Product Change Notification - SYST-21GKUR444

ERRATA - dsPIC33EPXXXGS70X/80X Family Silicon Errata and Data Sheet Clarification

Description of Change: Added silicon issue 30 (I 2C). This revision of the document shows changed bit representation (e.g., <3:0> changed to [3:0]) to be consistent with SDL documents.

FIGURE 1:

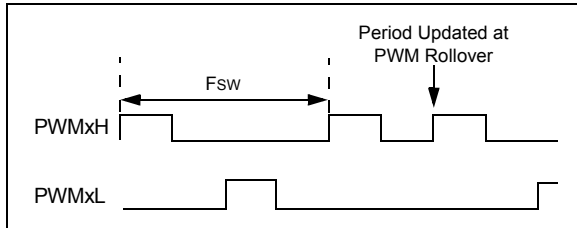
When the PWM module is configured for Push-Pull mode (IOCONx[11:10] = 0b10) with the Enable Immediate Period Update bit enabled (PTCON [10] = 1), a write to the Period register that coincides with the period rollover event may cause the push-pull output logic to produce back-to-back pulses on the PWMx pins (see Figure 1).

Ensure that the update to the PWM Period register occurs away from the PWM rollover event by setting the EIPU bit (PTCON[10] = 1). Use either the PWM Special Event Trigger (SEVTCMP) or the PWM Primary Trigger (TRIGx) to generate a PWM Interrupt Service Routine (ISR) near the start of the PWM cycle. This ISR will ensure that period writes do not occur near the PWM period rollover event.

FIGURE 2: EXAMPLE FOR REDUNDANT OUTPUT MODE

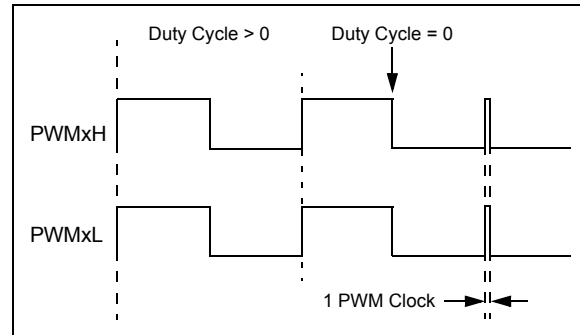
In the Redundant Output mode (IOCONx[11:10] = 0b01) and Push-Pull Output mode (IOCONx[11:10] = 0b10), with the Immediate Update Enable bit disabled (PWMCONx[0] = 0), when the Duty Cycle register is updated from a non-zero value to zero, a glitch pulse of a width equal to 1 PWM clock will appear at the next PWM period boundary, as shown in Figure 2 (for the Redundant Output mode). The Duty Cycle register refers to the PDCx register if PWMCONx[8] = 0 or the MDC register if PWMCONx[8] = 1.

If the application requires a zero duty cycle output, there are two possible work around methods:

1. Use the PWM override feature to override the PWM output to a low state instead of writing to the Duty Cycle register. In order to switch back to a non-zero duty cycle output, turn off the PWM override. The override-on and override-off events must be timed close to the PWM period boundary if the IOCONx register has been configured with IOCONx[0] = 0 (i.e., output overrides through the OVRDAT[1:0] bits occur on the next CPU clock boundary).
2. Enable the Immediate Update Enable bit (PWMCONx[0] = 1) while configuring the PWMx module (i.e., before enabling the PWMx module, PTCON[15] = 1). With the Immediate Update enabled, writes to the Duty Cycle register can have an immediate effect on the PWM output. Therefore, the duty cycle write operations must be timed close to the PWM period boundary in order to avoid distortions in the PWM output.

FIGURE 3: SIMPLIFIED BEHAVIOR

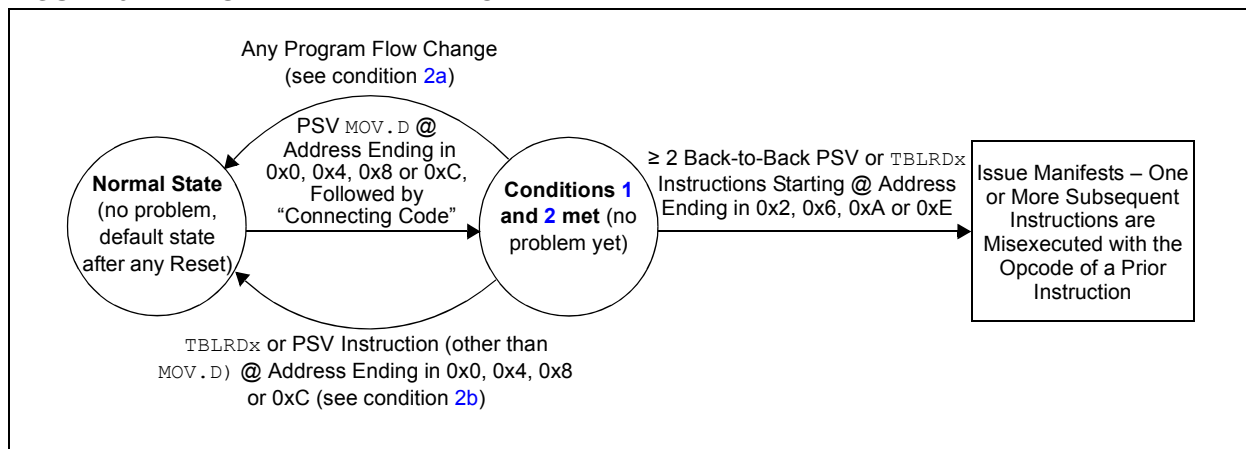
When two or more data Flash read instructions (via Program Space Visibility (PSV) read or Table Read) are executed back-to-back, one or more subsequent instructions can be misexecuted when all of the conditions in [Table 4](#) occur.

[Figure 3](#) provides an example of the effective behavior.

The issue can be avoided by ensuring any one or more of the requirements are not met. For example:

1. All instances of PSV `MOV.D` can be replaced with two PSV `MOV` instructions instead. Non-PSV `MOV.D` instructions acting on RAM/SFRs do not need to be modified; or
2. If not already present, a program flow change instruction (such as `BRA $+2`) can be inserted above back-to-back data Flash read sequences; or
3. Back-to-back data Flash read instruction sequences can be broken up by inserting a non-Flash read instruction (such as a `NOP`), in between the Flash read instructions; or
4. The alignment of the code can be shifted to avoid the required opcode location addresses.
